**RAI: M8**

**Response: M8**

### **RAI: A8.1**

#### **A4A.10 TN-40HT STORAGE CASK END DROP ANALYSIS**

**FIGURE A4A.10-1**  
**OVERVIEW OF FINITE ELEMENT MODEL**

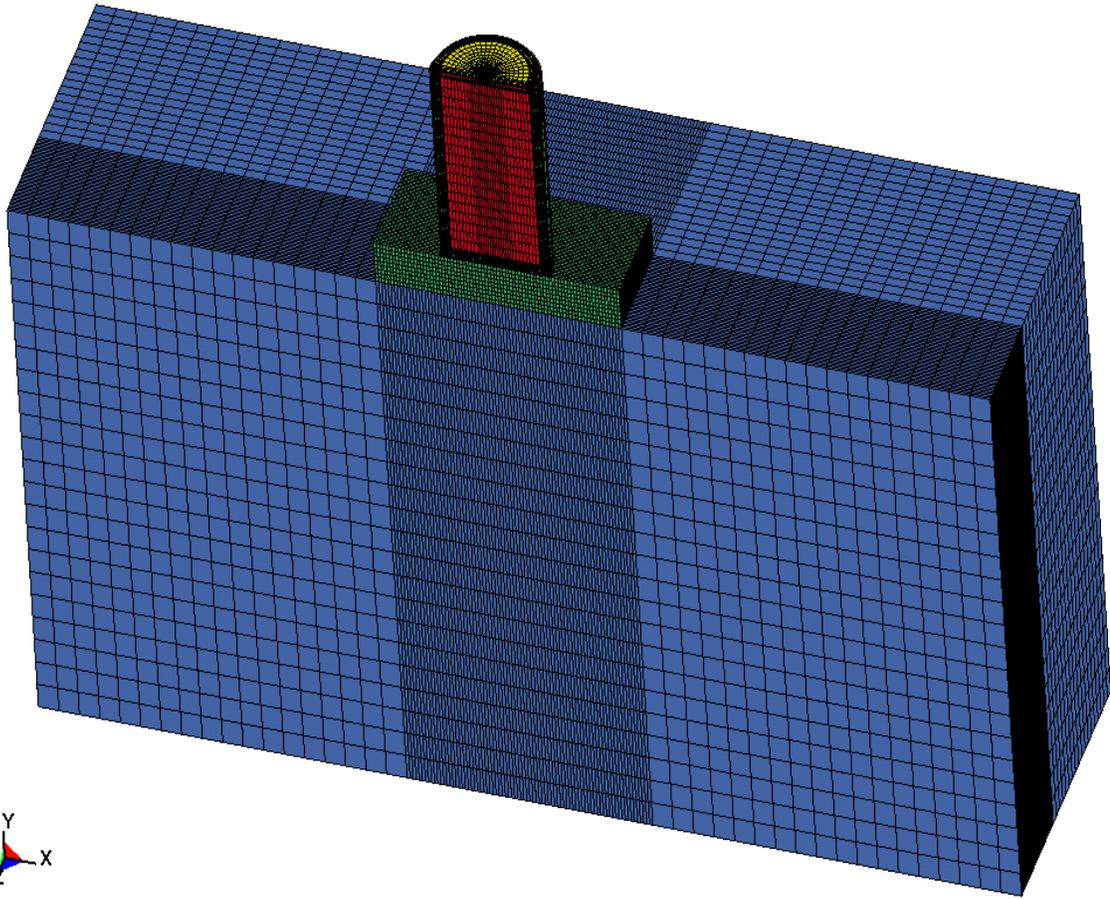
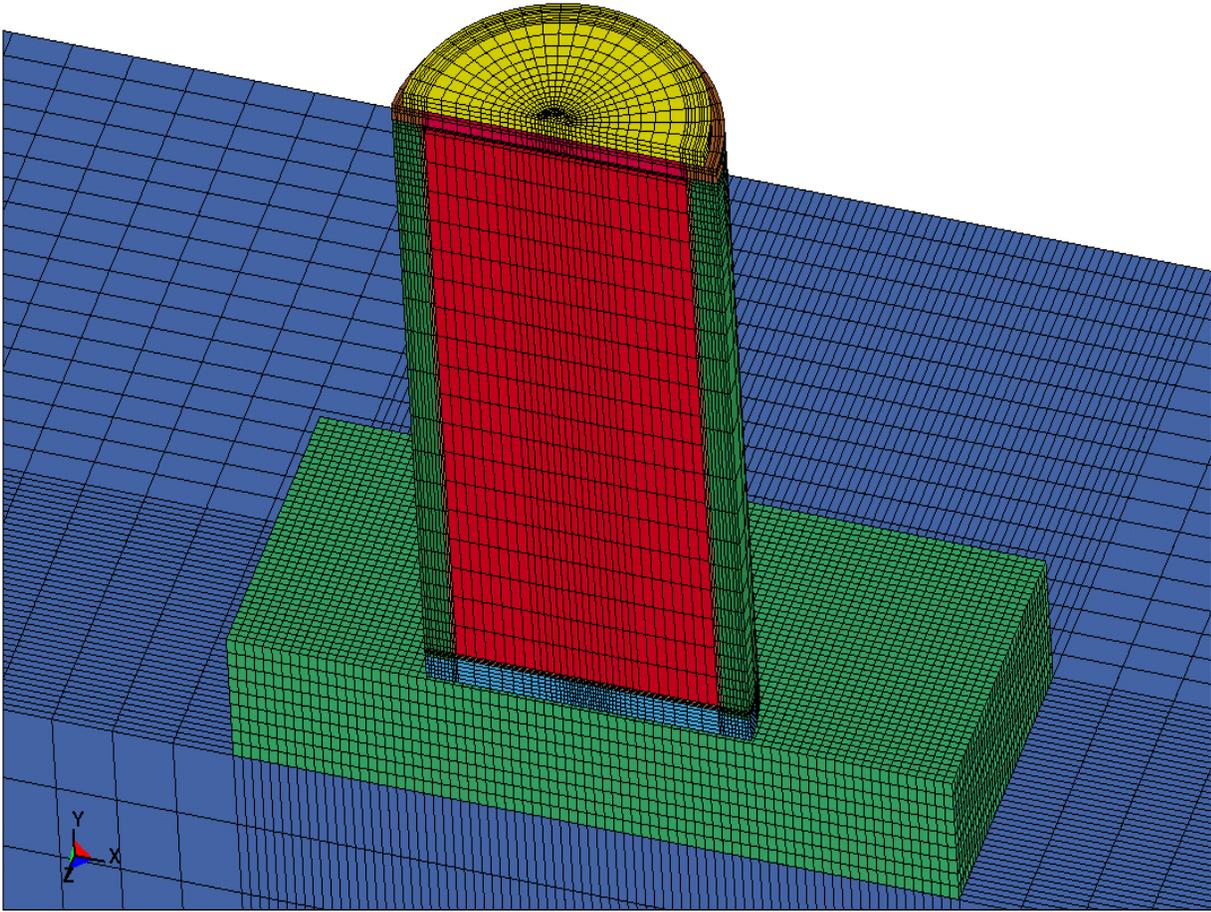
Considering the approach similar to that for the NUHOMS-HD storage system (Docket 72- 1030), perform a transient dynamic impact dynamic analysis of the cask for the 18-inch handling end-drop accident to define applicable loading conditions for cask component evaluations.

internals, concrete and base soil is shown in Figure A4A.10-1 and Figure A4A.10-2.
